Work Order ID 84882

Item Name: Skidtube LH

DART SERVICE INSTRUCTION

TO AMEND INSTALLATION INSTRUCTIONS IIN-D209-669 REV. B

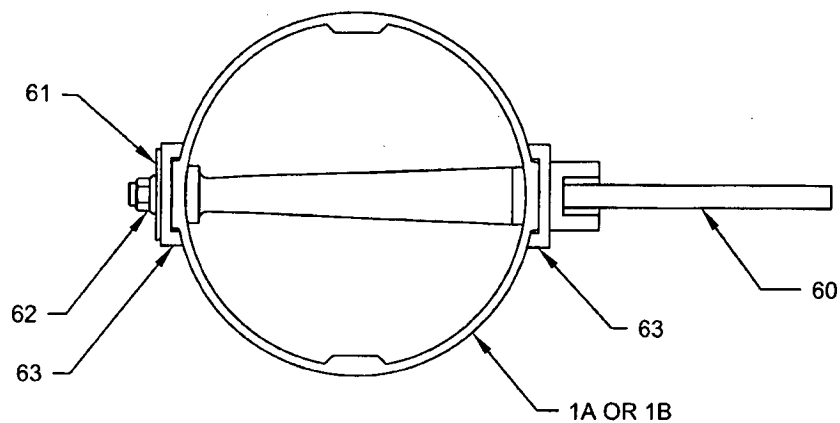
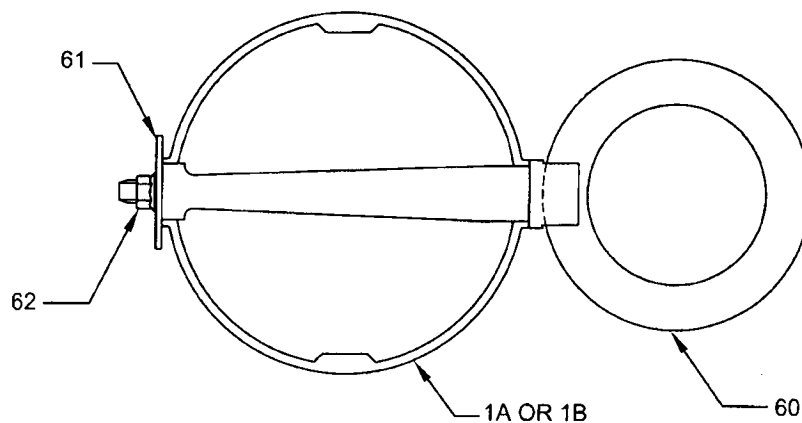
INSTALL TOW RING ASSEMBLY AS SHOWN BELOW (REFER TO SECTION F-F OF IIN-D209-669 REV. B.
